## Access Compliance Report Public Rights-of-Way (Curb Ramps)

Intersection ID: 27236 Main Street: BALLANTYNE\_CORPORATE\_PCross Street: BRIXHAM\_HILL\_AV Location: W

ADA ID: 344C7D927F75 Ramp Type: Perp Initial Pass/Fail: Fail Overall Compliance: No Severity Score: 1.25

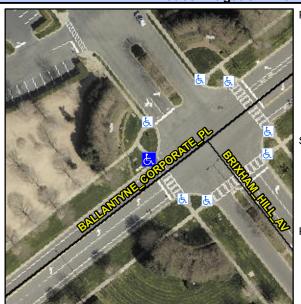
| Compliance Description |                       | Data  | Compliance Description |                             | Data |
|------------------------|-----------------------|-------|------------------------|-----------------------------|------|
| Yes                    | Ramp Width (in)       | 48.0  | No                     | Ramp XSlope (%)             | 3.1  |
